From: [Ralph Willson](#)
To: [Draft EIS Feedback;](#)
CC:
Subject: Response to Draft EIS on Columbia River Crossing
Date: Tuesday, July 01, 2008 12:04:56 AM
Attachments: [ALTERNATIVE3-8.5x11.pdf](#)

ALTERNATIVE 3 WITH LIGHT RAIL TERMINUS AT I-5 FREEWAY CAP PLAZA

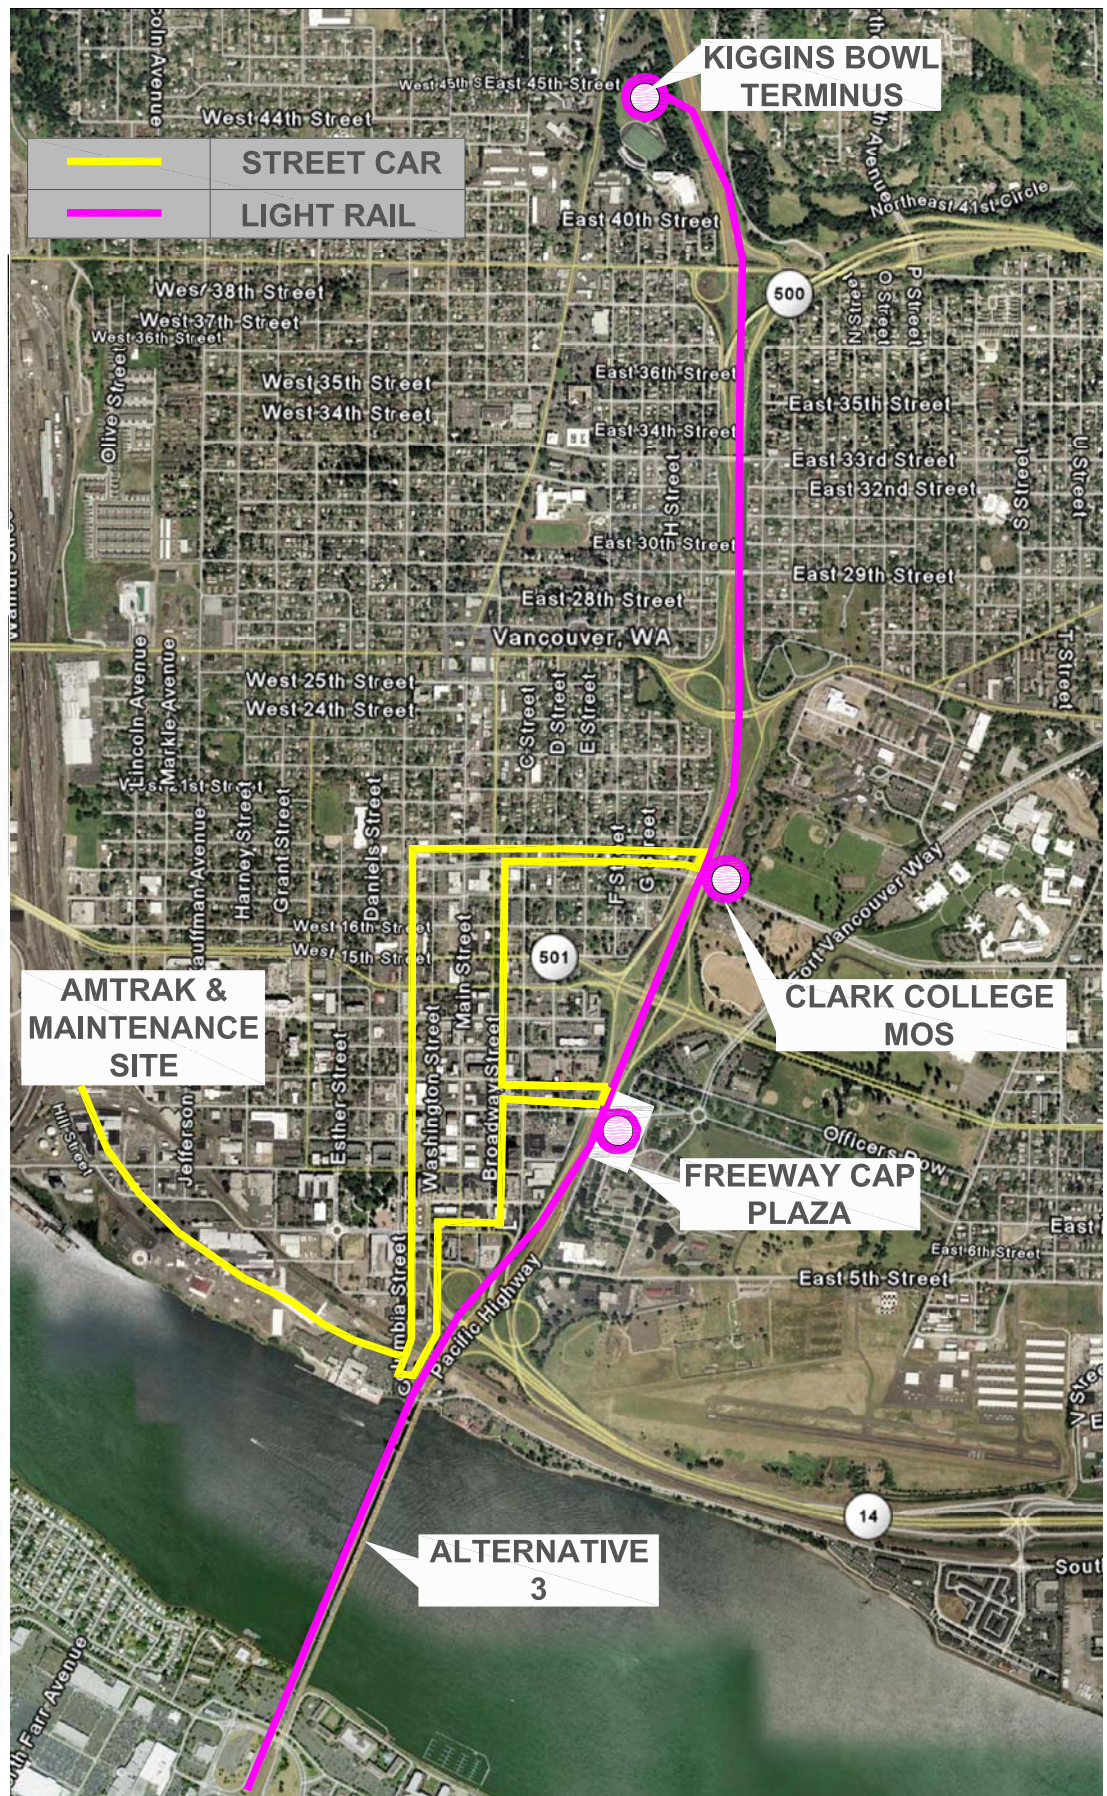
Whether or not the Freeway Cap is included in the CRC project, I would ask that the Columbia River Crossing Task Force to review the environmental impacts of Alternative 3, with the option of landing the first stop of Light Rail on the Freeway Cap or in its proposed vicinity, and continuing the Light Rail north along the freeway (perhaps elevated, but within the freeway right-of-way) to the proposed Clark College Minimum Operable Segment (MOS), and eventually to the Kiggins Bowl Terminus. It is my belief

that this is a more environmentally sound option and sets up a Light Rail future system up Highway 99 to north Clark County and will be useful to promote future urban density.

I would ask the Columbia River Crossing Task Force to work with the Federal Government to modify funding sources to allow the money that was going to be used to construct Light Rail through downtown Vancouver to be available to construct a Streetcar System that would share traffic lanes with automobiles at approximately 50% to 60% of the cost of Light Rail. I believe this is a more economically sustainable option to running Light Rail through our historic neighborhoods and in fact echoes a past tradition of streetcars serving these same neighborhoods as proposed in the Light Rail couplet.

- Ø Use high capacity transit corridors for high capacity transit. Keep the majority of commuters on or along the I-5 corridor. Do not force commuters to make unwanted and time consuming stops through downtown Vancouver.
- Ø Use Light Rail where it works best, in moving commuters quickly, with stops spaced out for quick, efficient travel.
- Ø Use Streetcars to mix with the automobiles to support urban density and urban lifestyles, moving people within our city to connect to rapid transit or Light Rail.
- Ø Compare environmental impacts of the Light Rail to the Streetcar couplets.
- Ø Compare economic development between the Light Rail and Streetcar couplets.

I have attached a PDF diagram of this Alternative 3 with Light Rail landing at the proposed Freeway Cap, extending north to the Clark College MOS and then on to Kiggins Bowl Terminus. This diagram shows the use of a proposed Streetcar system in lieu of the proposed Light Rail system through downtown with connections to the Freeway Cap and Clark College Light Rail stops.
